## E C R Printout

ECR NUMBER: OC 06-00879 001ECR TYPE: DCPASSIGNED ORG: OEDMPRINT DATE/TIME: 11/06/06 07:52ASSIGNED INDV: MARKOSREQUIRED DATE: 11/06/06INITIATOR: TAMBURROECR STATUS: DISPONREQUEST ORG: OEDSTATUS DATE: 11/05/06A/R NO: A2152754INIT. DATE: 10/24/06PROJECT NO:           A/R STATUS: ASIGNDA/R SUBJECT: DRYWELL FLOOR/TROUGH/DRAINAGE INSPECTIONS AND REPAIRS

DURING 1R21, WATER WAS DISCOVERED IN THE EXCAVATED TRENCH OF THE DRYWELL ELEVATION 10'-3" FLOOR. THIS ECR WILL PROVIDE FOR INSPECTION AND REPAIR OF THE DRAINAGE PROVISIONS FOR THIS FLOOR, AS WELL AS PROTECTION OF THE DRYWELL SHELL.

DRAWING AFFECTED:  
BR 4070 SH.1

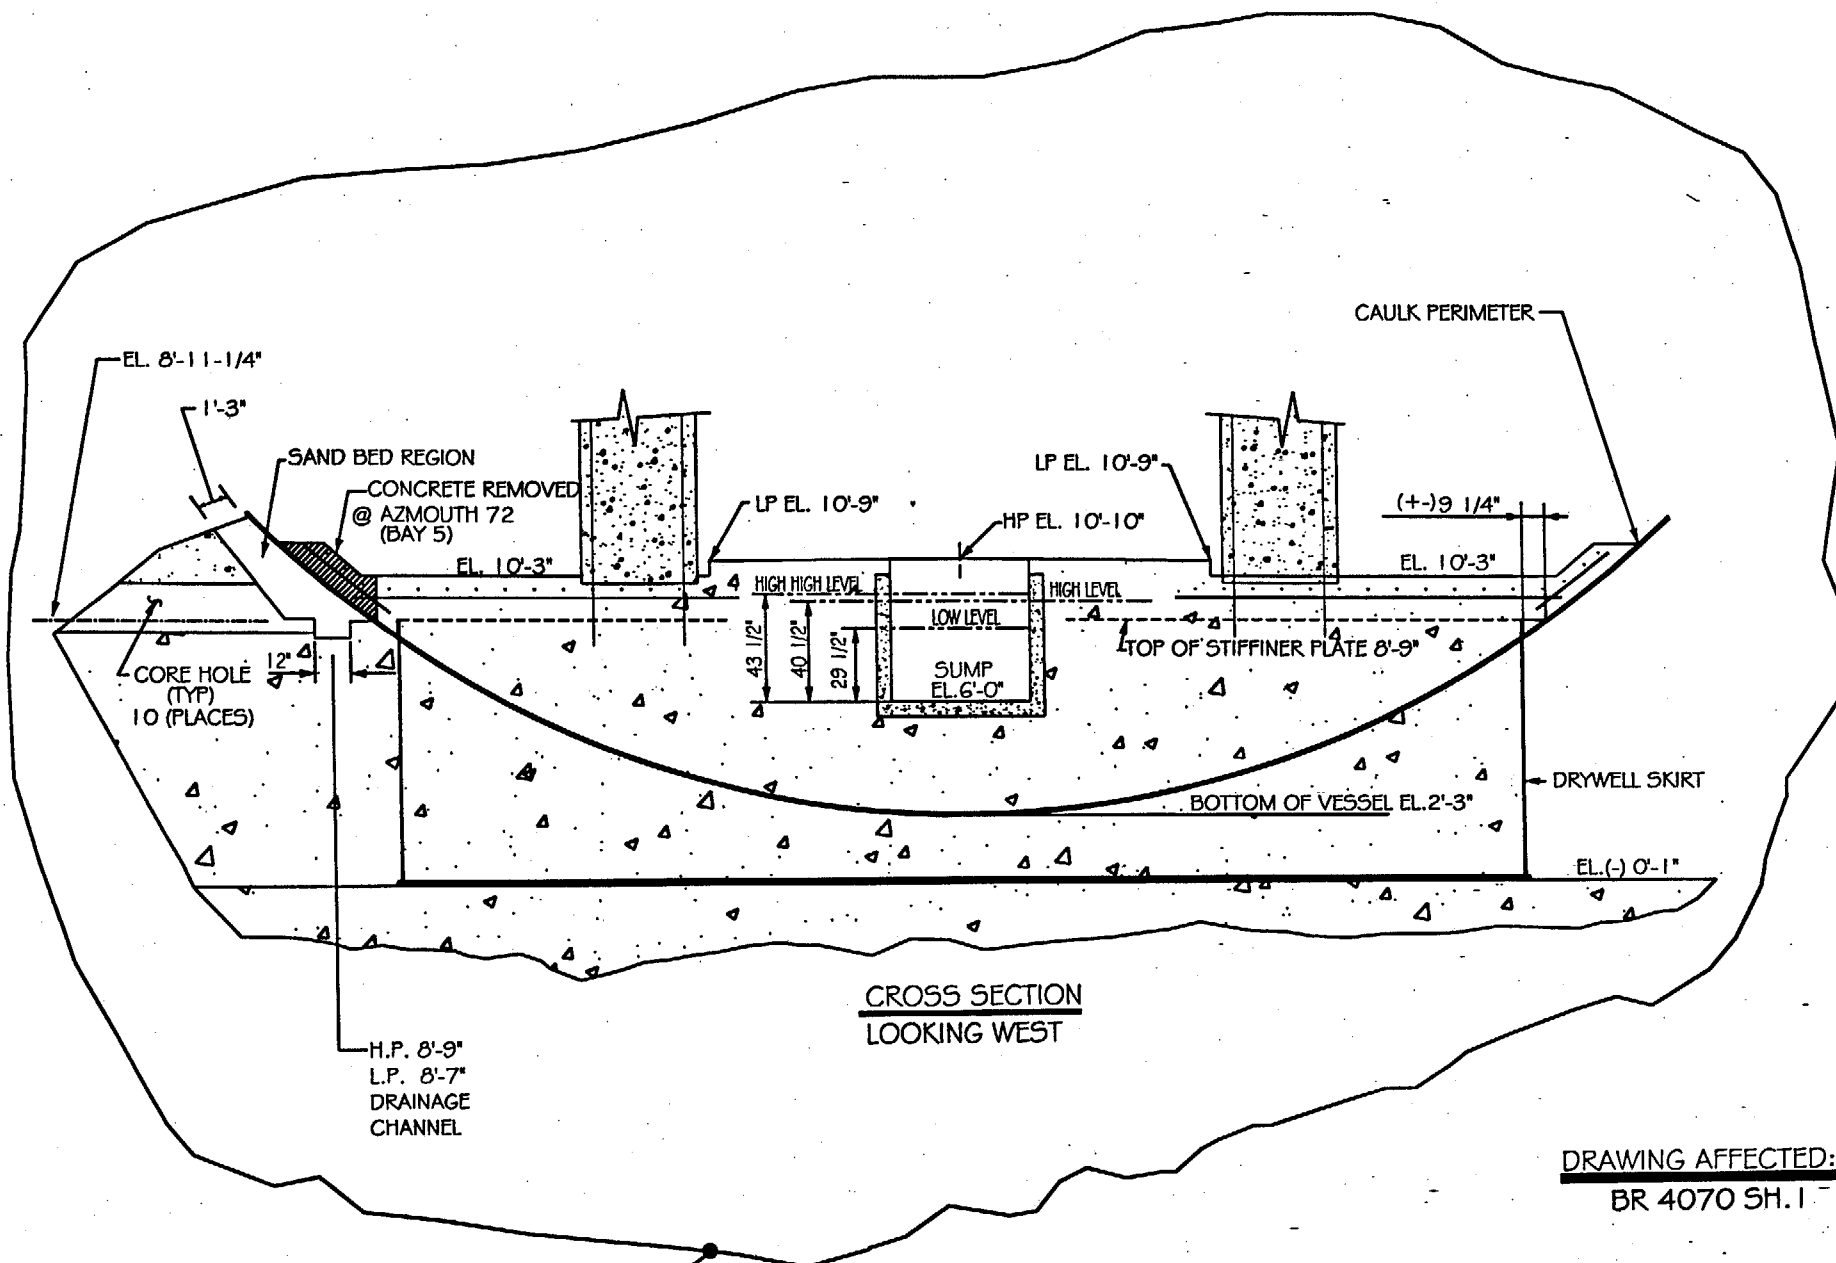
Drawing BR 4070 sheet 1 is posted by this ECR, to show the caulk installation.
